INCORPORATED COUNTY OF LOS ALAMOS

Invitation for Bids No. IFB25-19

**NM State Rd 4 - 16" Water Transmission Line Replacement - Fiber Conduit
Installation**

Addendum No. 5

THRUST BLOCK FOR TEES, CAPS AND PLUGS

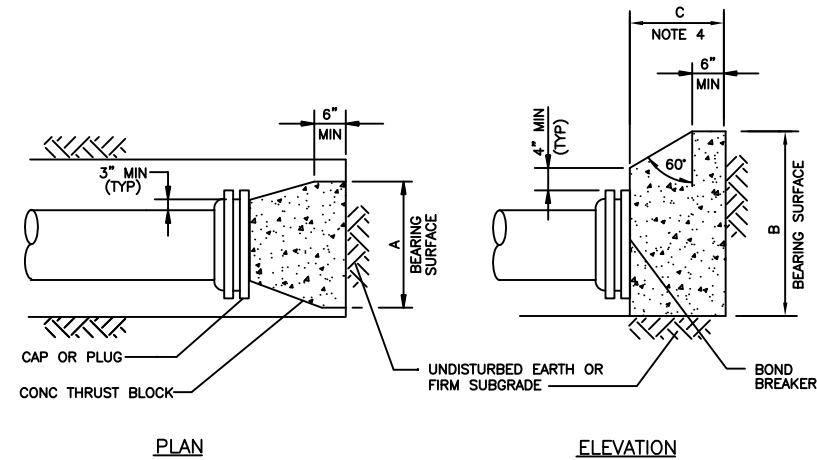
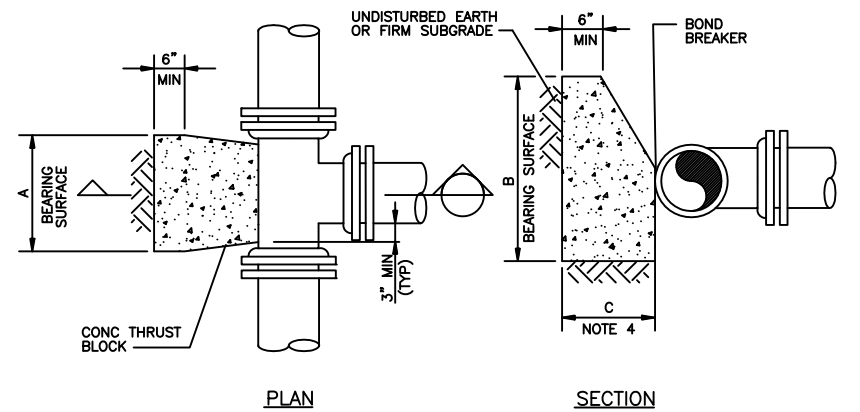
22. Thrust block details are not indicated on the plans. Please confirm thrust blocks are not required at bends.

RESPONSE: Thrust Blocks are required; please see attached detail for thrust blocks.
